Hearings Panel

Worcester Street and Antigua Street Central City Cycleway Connections

AGENDA

Worcester Street (Manchester Street to Fitzgerald Avenue)
Project No.1 - Worcester St
Plan for Approval

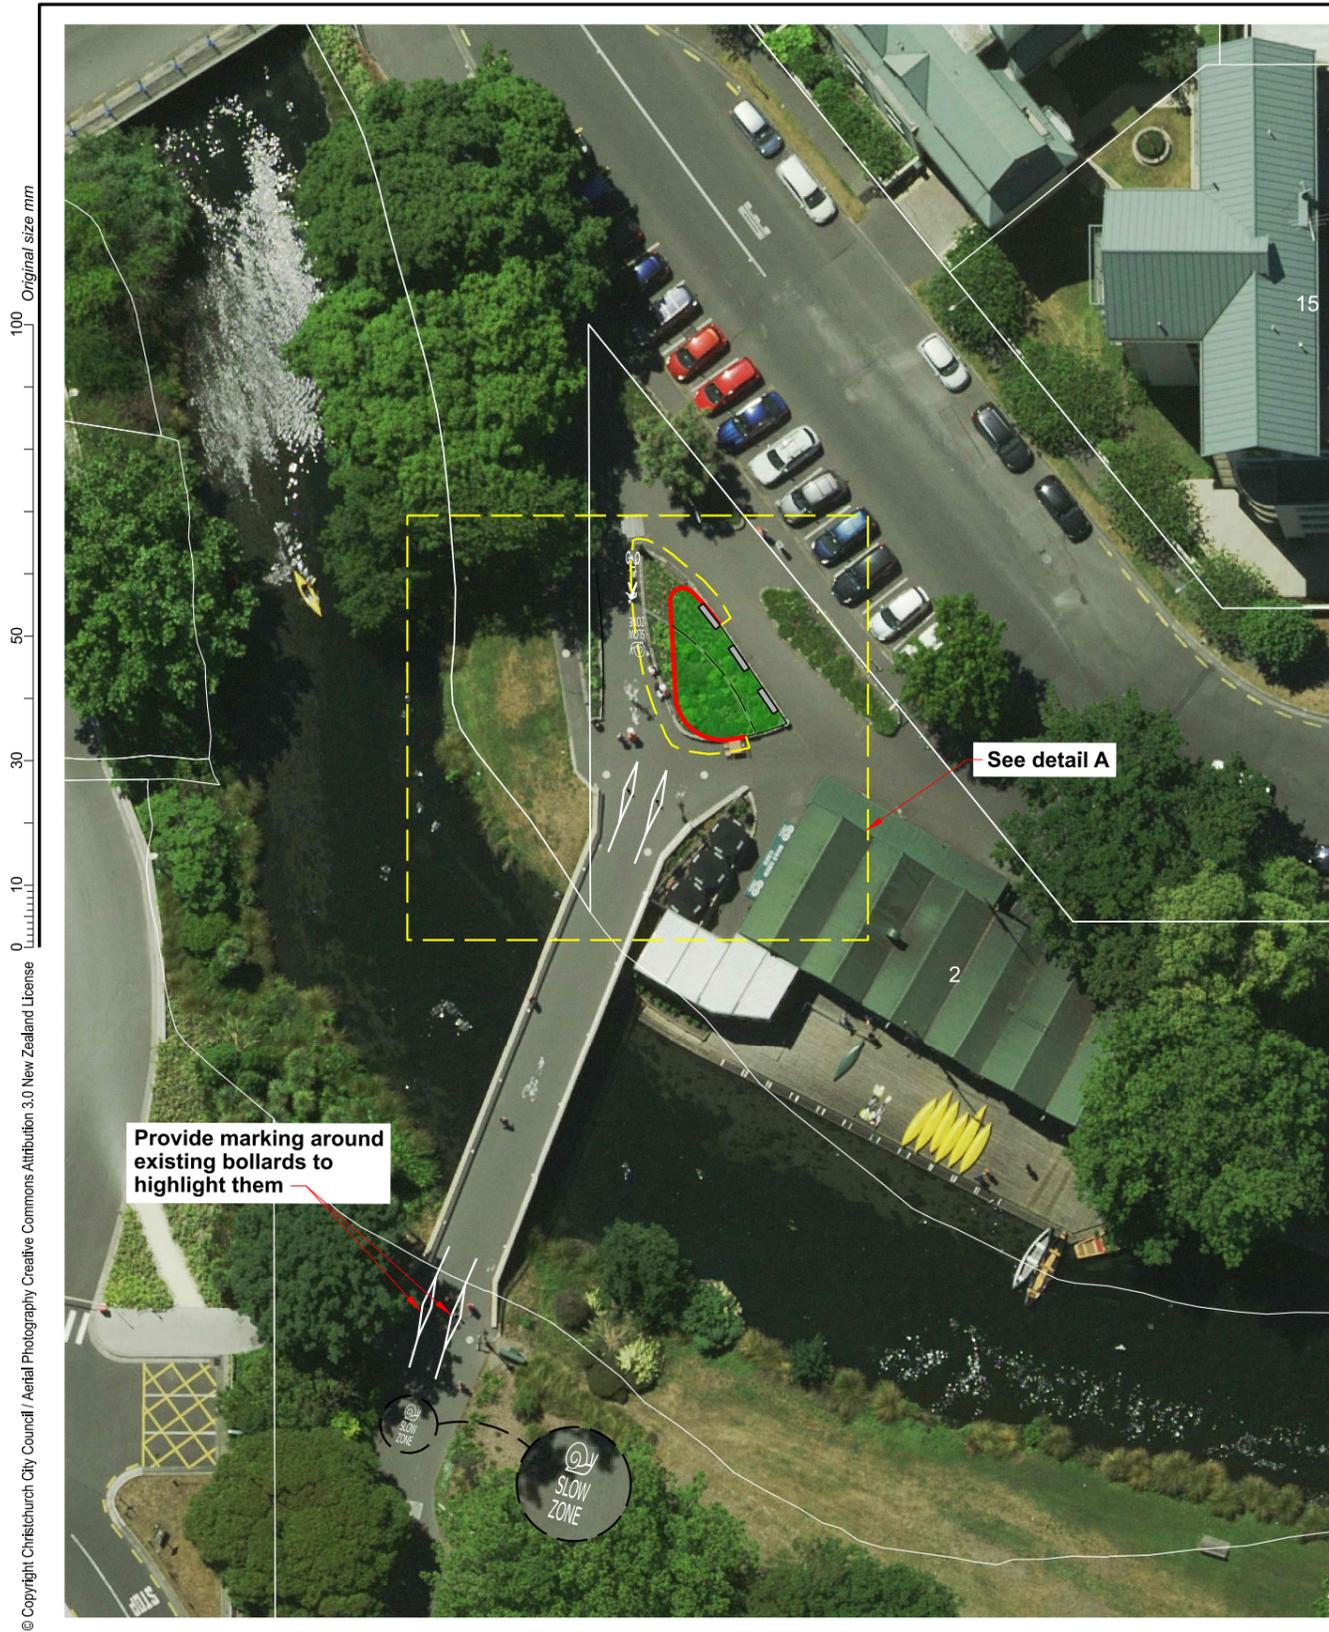
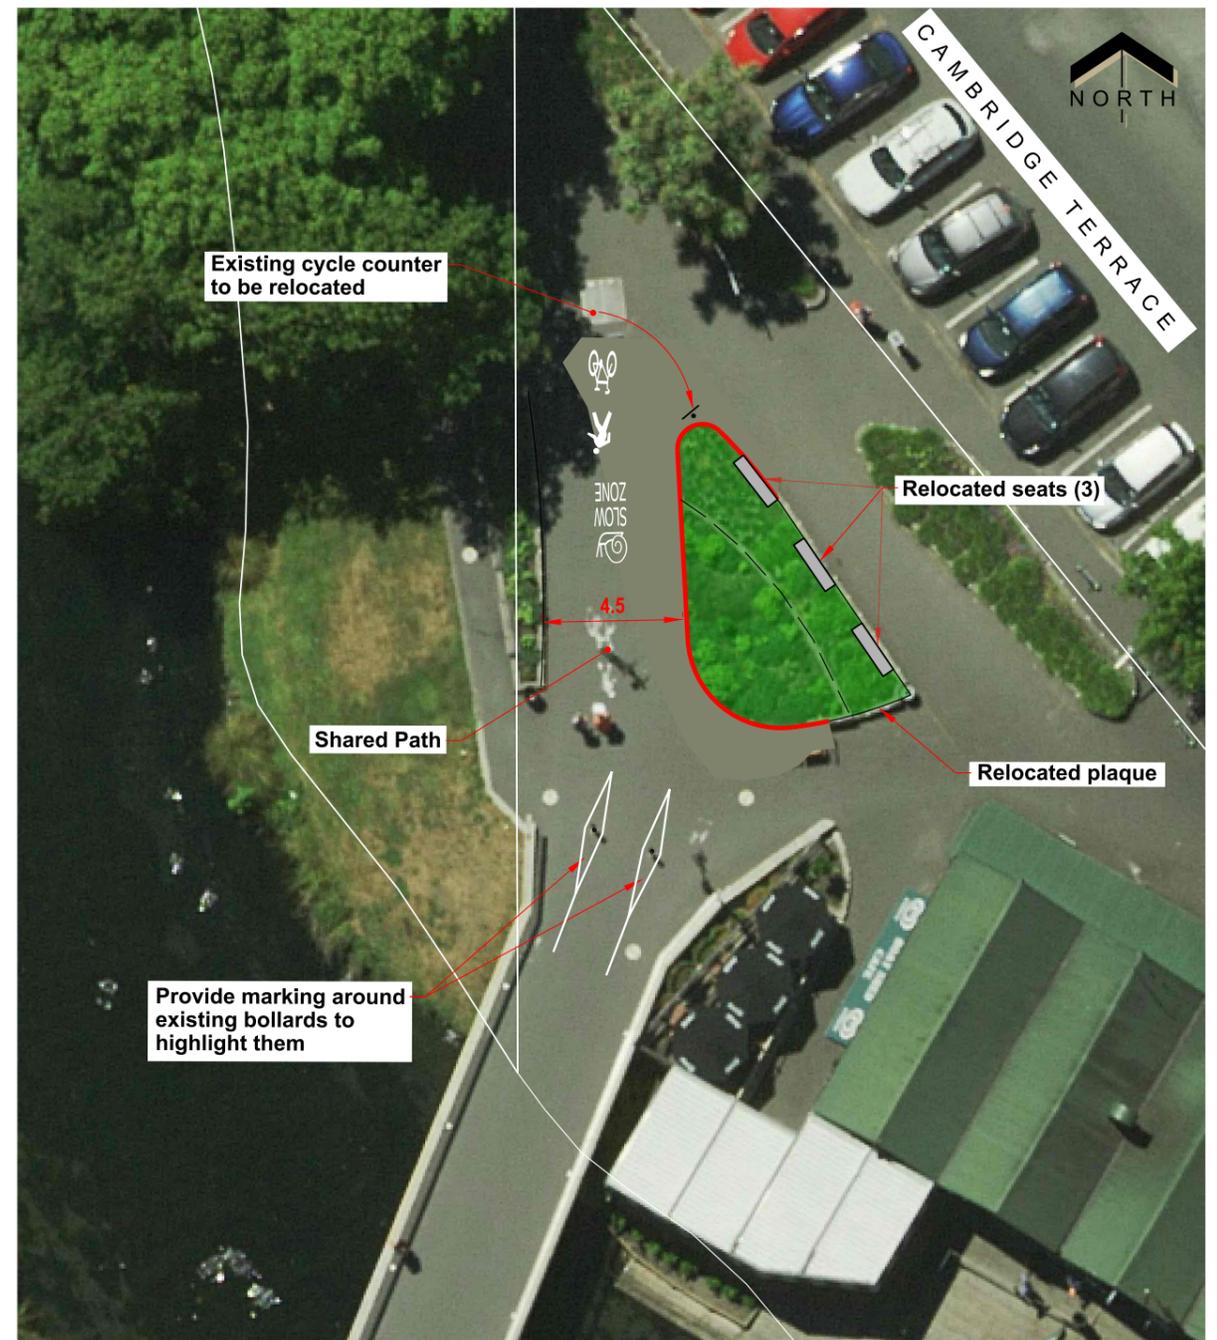
- The planter should be removed entirely (4) and the other smaller planter should be narrowed (1).

Response: This planter was installed by the Cancer Society. We have permission to narrow the planter but not to remove it.

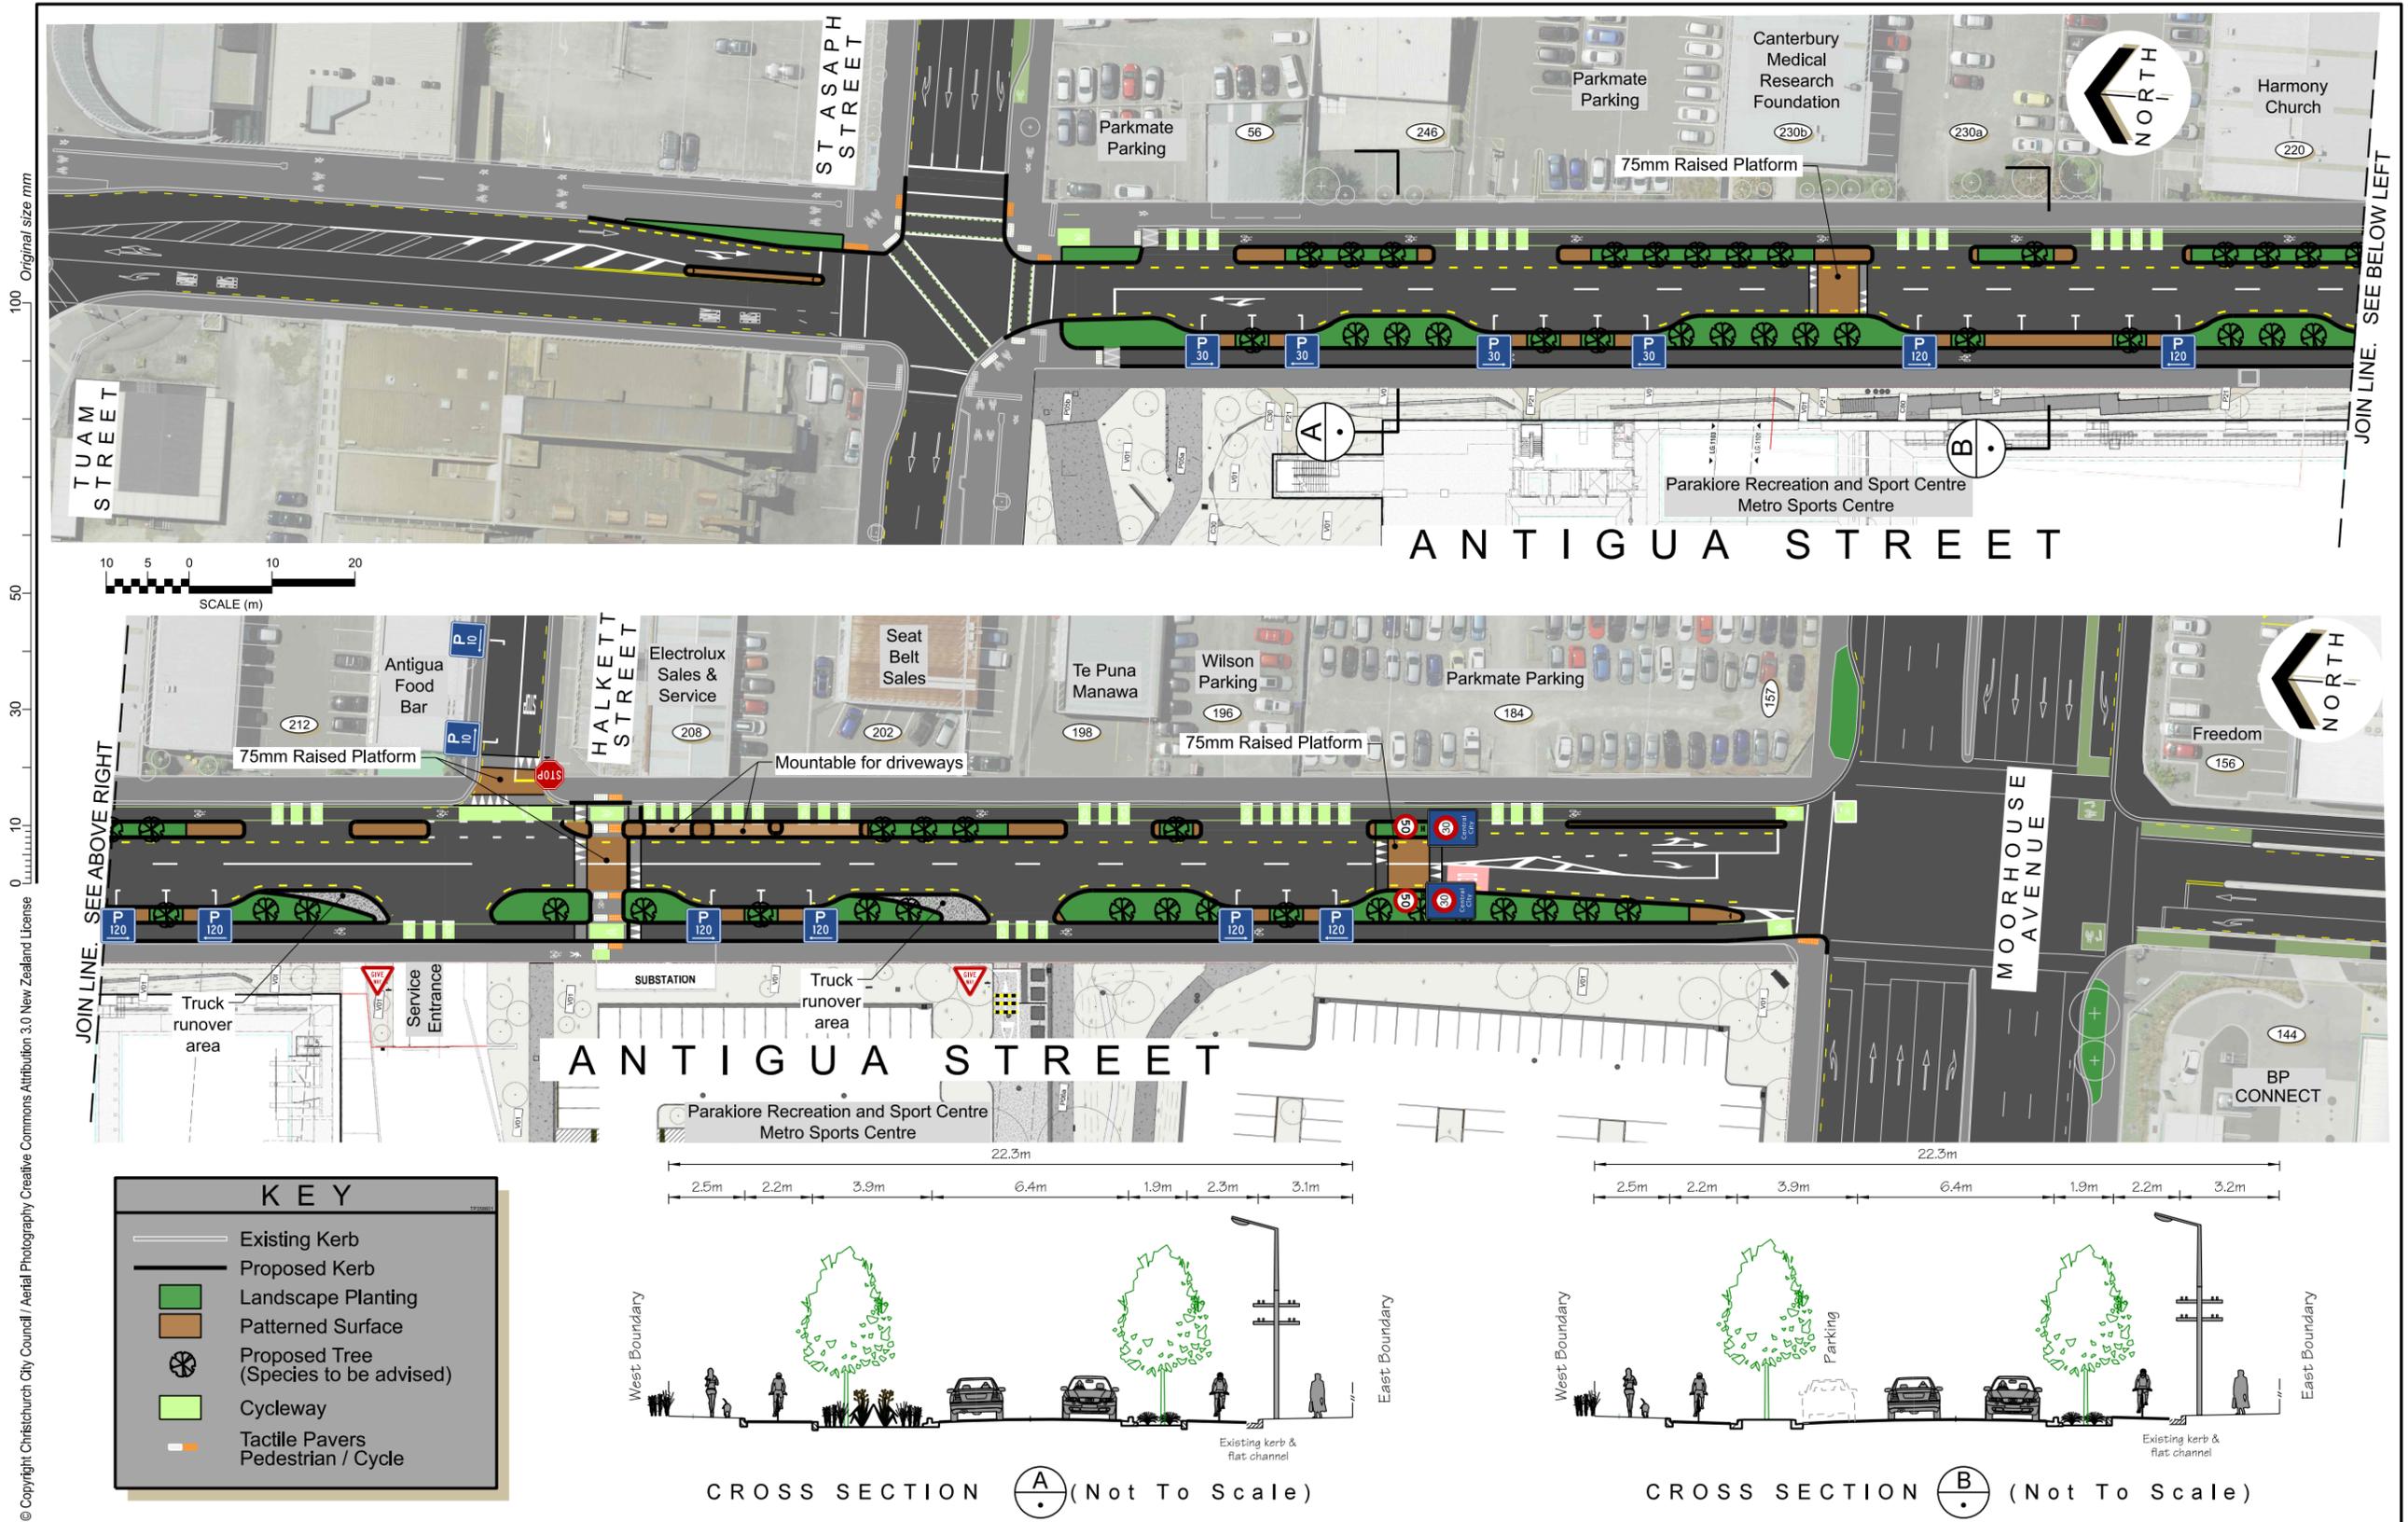
- 8.8.3 Too many trees proposed which impacts on visibility for cyclists, drivers and pedestrians, could lower planting be considered, more parking could be made available with less trees (18).

- This will be addressed with the cyclists being separated.
- 8.8.6 Would like the proposed cycleway wider than 2.2m (10).
- The proposed cycleway width is consistent with national guidance for the levels of cycling demand. There will be localised widening due to the adjacent low kerb which will provide additional opportunities to overtake in some locations.

- 8.8.7 Concern at the loss of parking and the remaining parking being time restricted (10).
- Parking removal is required to allow for the separated cycleway and to provide clear sightlines and access ways. The remaining parking has been made time restricted to allow for parking turnover for the local businesses and visitors to the hospital. There is future parking planned in a number of areas within this part of the city.

- The proposal has been modified to remove some trees to improve visibility between drivers, cyclists and pedestrians. This reduction in trees will not result in any increase in parking spaces.

Figure 3.1 Potential trip hazard for car passengers crossing the cycleway to access the footpath

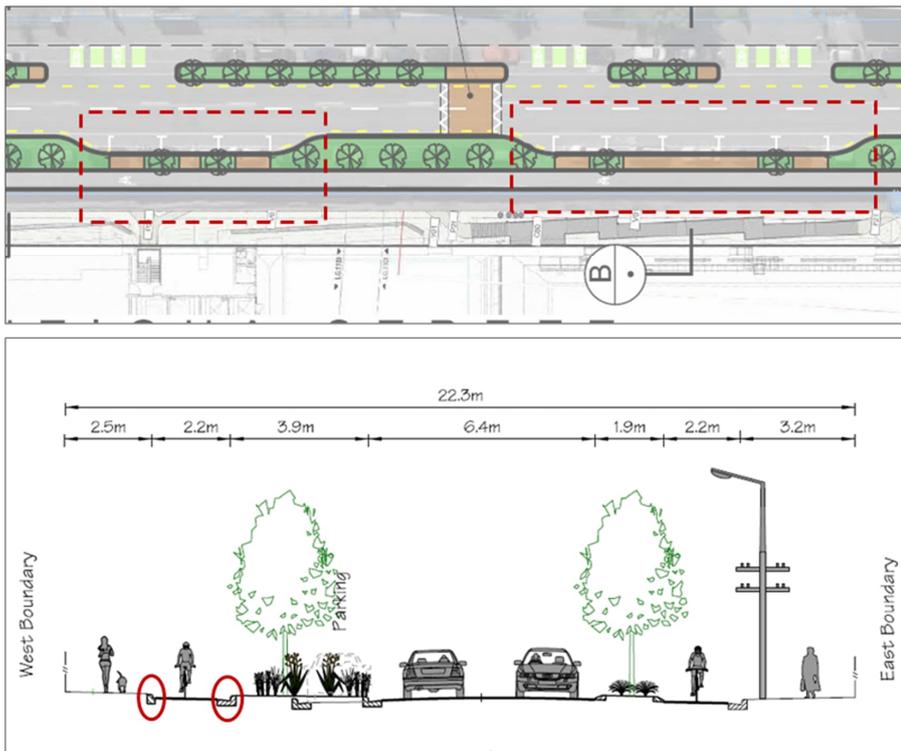
Passengers getting out of a vehicle parked in a parallel parking space on the west side will have to cross the cycleway to get onto the footpath. The level difference between the island separating parking from the cycleway, and then the cycleway and the footpath creates a potential trip hazard (see Figure 3.1). Also, car passengers may fail to appropriately look for cyclists, as this is not a common arrangement within the city that people are generally used to.

Given that on street parking is likely to be well used by the visitors to the Metro Sports facility, the frequency of the risk occurring is likely to be common.

Designer Response	Agree with concern, though the raised kerb separation is consistent with other recent CCC off-street cycle lane proposals and we intend to retain it. Nevertheless we can reduce the likelihood of the risk; the parking restriction period is now proposed to be predominantly P120, as recommended. Amongst the 16 parking spaces, 11 are now P120 restrictions.
Auditor Response	Agree with Designer response but suggest monitoring how the P30 spaces operate from an user interaction perspective, this can be done during the Post Construction Safety Audit.
Safety Engineer	
Client Decision	Agree with Auditor and Designer comments
Action Taken	Network Operations to complete monitoring. To be followed up.

Figure 3.3 Recommendation for installing hardstand areas

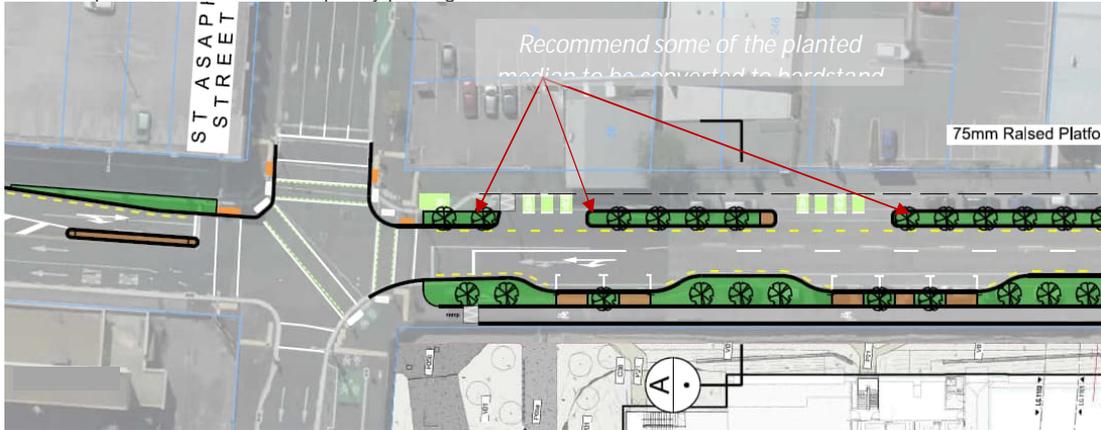
During the site visit it was observed that some businesses on the east side of Antigua Street have wheelie bins (see [Figure 3.2](#)). It is important to ensure that there are handstand areas on the cycleway separator island to appropriately place the wheelie bins, so that the collection arm of the refuse trucks will not have to extend across the cycleway to collect the bins from the footpath. The collection arm having to go across the cycleway is highly undesirable as it presents a hazard for the cyclists. Truck operators may fail to appropriately check for cyclists or not see them properly through the rear-view mirrors prior to operating the arm, and cyclists may not have adequate time to react and avoid a collision.

Towards the Moorhouse Ave end of the corridor, where the businesses are currently located, the design appears to have considered this risk and handstand areas are provided. But towards the northern end, the separator island is predominantly planted. It is acknowledged that currently there is no demand for bin collection at the northern end as land is mostly used as temporary parking. However, it is expected that this land will be developed in future.

It is recommended that some areas of hardstand are included at the St Asaph Street end of the corridor to future proof for development on the current temporary parking sites.

Designer Response	Agree with the concern and the layout has been changed to provide more hard standing areas to accommodate wheelie bins.
Auditor Response	Agree with Designer response
Safety Engineer	
Client Decision	Agree
Action Taken	Layout changed.

Figure 3.4 Possible obstruction to traffic light visibility by trees

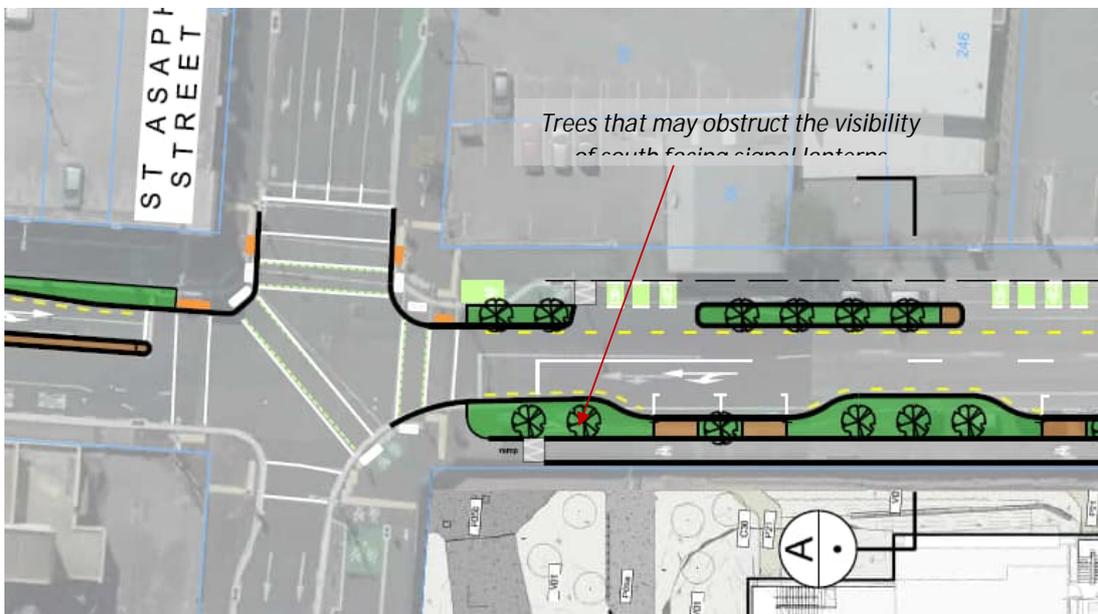
As shown in **Figure 3.4**, the trees proposed on the southern approach of the Antigua Street/ St Asaph Street intersection are likely to obstruct the visibility of the south facing signal lanterns for northbound drivers. This can increase the risk of unintentional red light running.

In addition to the risk of 'T-bone' crashes, the central city location with high pedestrian volumes (which will likely increase when the Metro Sports Facility opens) and a major cycleway on St Asaph Street going through the intersection means red light running carries a high risk of a crash involving pedestrians or cyclists. However, the 30km/h speed limit on all approaches reduces the likelihood as well as the severity of a crash.

It is recommended that planting on approach to the intersection is kept low.

Designer Response	Agree with concern; trees have been removed on the east and west sides approaching the traffic signals, to improve the forward visibility to the signal lanterns.
Auditor Response	Agree with Designer response
Safety Engineer	
Client Decision	Agree
Action Taken	Trees removed
